DART SERVICE INSTRUCTION

TO AMEND INSTALLATION INSTRUCTIONS IIN-D407-781-2 REV. A OR LATER APPROVED REVISION
AND INSTRUCTIONS FOR CONTINUED AIRWORTHINESS ICA-D407-781 REV. 3 OR LATER REVISION

A	NEW ISSUE		13.04.08
REV.	DESCRIPTION	BY	DATE
DESIGN		DART AEROSPACE LTD HAWKESBURY, ONTARIO, CANADA	
DRAWN		DRAWING NO. REV. A	
CHECKED		DSI 9649 SHEET 1 OF 2	
MFG. APPR.	N/A	SCALE	
APPROVED		TITLE NTS	
DE APPR.		ALTERNATE INSTALL	
DATE	13.04.08	COPYRIGHT © 2013 BY DART AEROSPACE LTD. THIS DOCUMENT IS PRIVATE AND CONFIDENTIAL AND IS SUPPLIED ON THE EXPRESS CONDITION THAT IT IS NOT TO BE USED FOR ANY PURPOSE OR COPIED OR COMMUNICATED TO ANY OTHER PERSON WITHOUT WRITTEN PERMISSION FROM DART AEROSPACE LTD.

**FIGURE 1 - D3879-1 BAGGAGE COMPARTMENT WALL
PROTECTOR - ALTERNATE INSTALLATION**

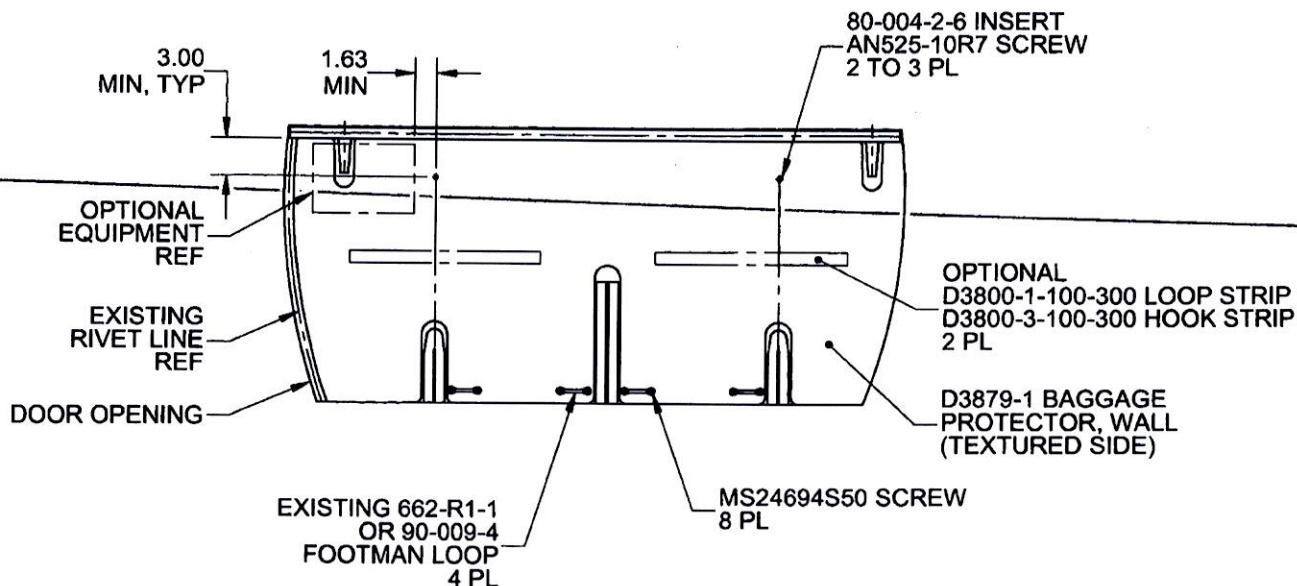
In some aircraft, the top portion of the D206-781-041 Baggage Compartment Wall Protector Kit cannot be installed as indicated in IIN-D407-781-2. The purpose of this DSI is to provide an alternate mounting method to fasten the top portion of the D206-781-041 Baggage Compartment Wall Protector Kit.

It is acceptable to replace qty(2) D3930-1 Clips with qty(2) 80-004-2-6 Inserts. Locate and mark location of the two attachment holes on the baggage compartment wall as shown in Figure 1 of this service instruction. Install 80-004-2-6 Inserts at the marked locations in accordance with Section 3-2-12 of BHT-206-SRM-1. It is acceptable to trim the wall protectors to accommodate optional equipment or transfer attachment holes to the wall protector and install the optional equipment on top of the wall protector with longer fasteners.
